CASE SUMMARY SHEET**CASE NUMBER: SUP24-03-03****DATE RECEIVED: February 23, 2023****DATE OF MEETING: March 12, 2024 and March 26, 2024****Address: 1943 Lakeshore****Subdivision: City of Mandeville, Square 2 Lot 2A****Zoning District: B-3 Old Mandeville Business District****Property Owner: Cayman Sinclair****Previous Case: Z15-08-09**

REQUEST: SUP24-03-03 – Cayman Sinclair requests a revision to Special Use Approval Z15-08-09 per CLURO Section 4.3.2.11. Amendments to Special Use Permit Approvals, City of Mandeville, Square 2 Lot 2A, B-3 Old Mandeville Business District, 1943 Lakeshore Drive

CASE SUMMARY SHEET**CASE NUMBER: V24-03-13****DATE RECEIVED: February 23, 2023****DATE OF MEETING: March 12, 2024 and March 26, 2024****Address: 1623 Lakeshore****Subdivision: City of Mandeville, Square 5 Lot 5A****Zoning District: R-1 Single Family Residential****Property Owner: Johnny Swiger**

**DRAINAGE PLAN**
1"=10'-0"

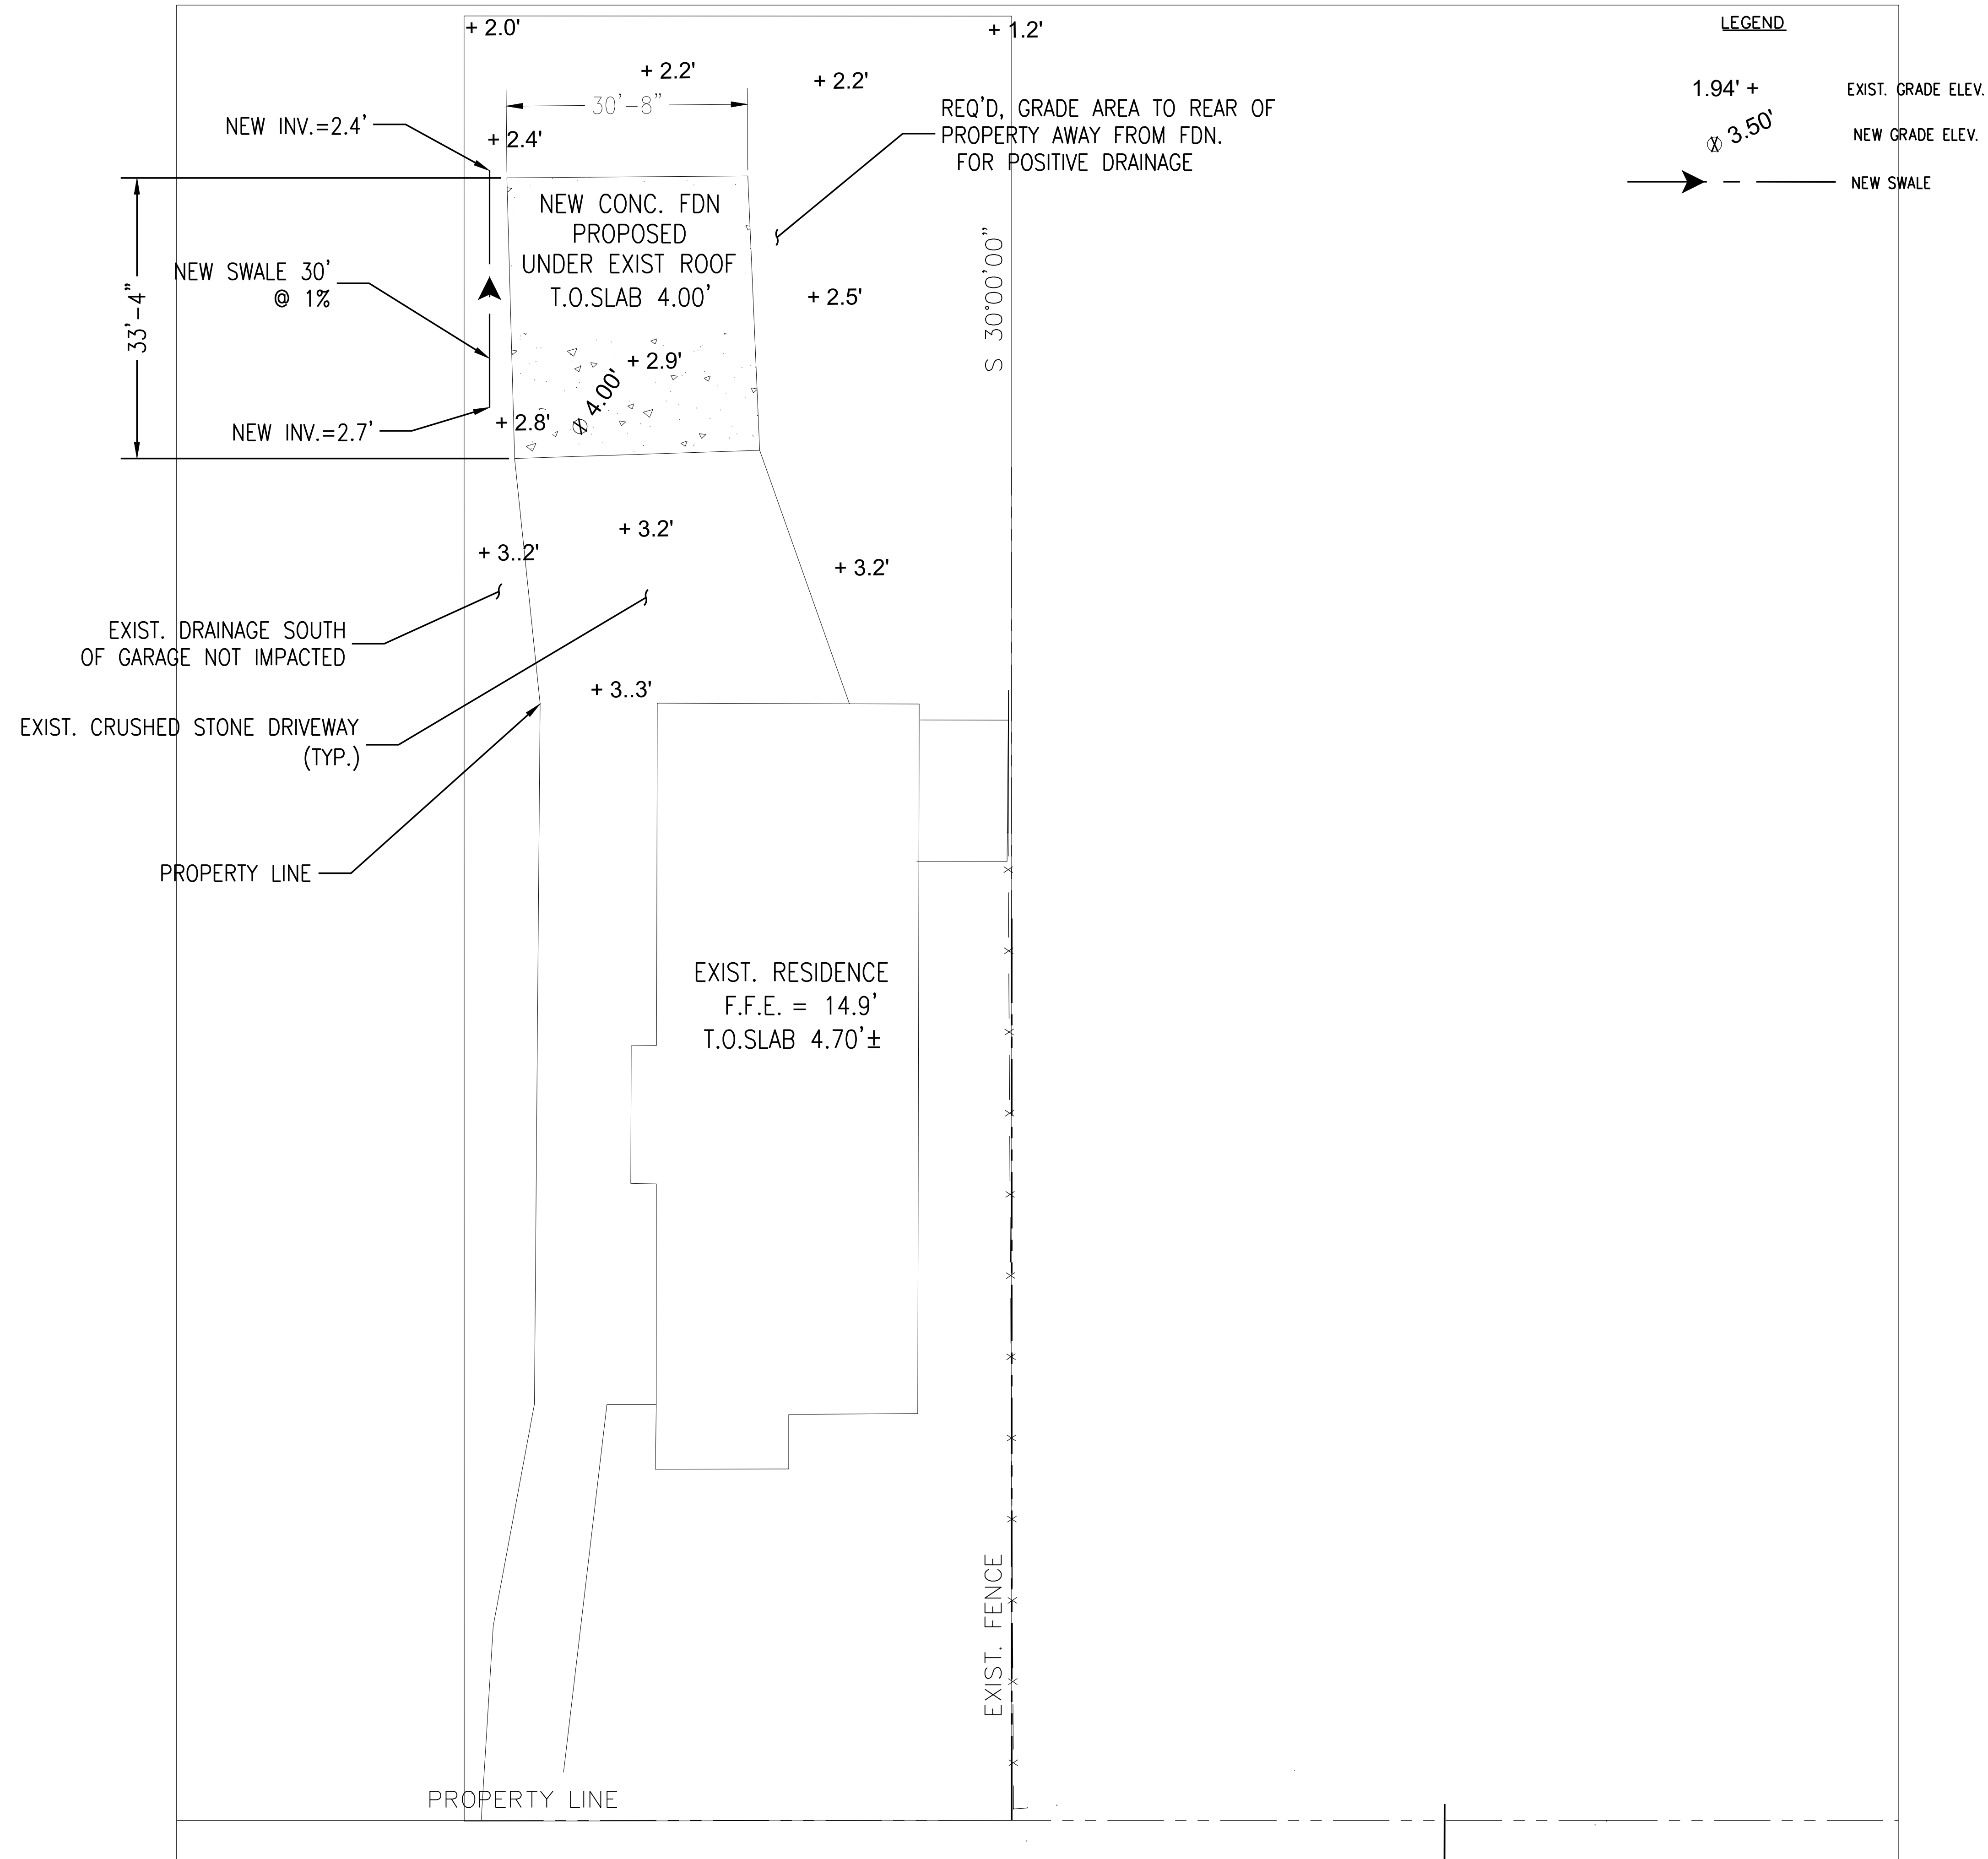
1. The proposed "REQ'D, GRADE AREA TO REAR..." does not have any proposed elevations or limits shown. The existing elevations demonstrate there is positive drainage to the rear and not necessary to fill.

2. The site plan indicates a walkway from the porch to the garage. This is not shown on the drainage plan and does not have any elevation data. If the walkway is to be elevated above 6" from grade, then the walkway should be included in the variance request.

3. Drainage Plan by Brain Froeba indicates a slab height of 4.00, site plan from John Bonneau shows a proposed FFE of 4.70. What one is the correct requested height?

4. The proposed is in the City's drainage overlay district and will require a Coastal Use Permit. Additional restrictions may apply pending there review.

At the March 12th meeting the commission requested some additional information pertaining to the comments made by Public Works. A revised drainage plan prepared by Specialized Engineering was submitted showing new swales constructed in the rear of the property to direct water along the natural path to Bayou Castine. The applicant also clarified at the meeting that the covered walkway shown on the plans has been removed. It was also clarified by the engineer who prepared the drainage plan that the slab under the carport will be at a height of 4', with the 4.7' shown on the plan prepared by John Bonneau being the height of the slab under the house.
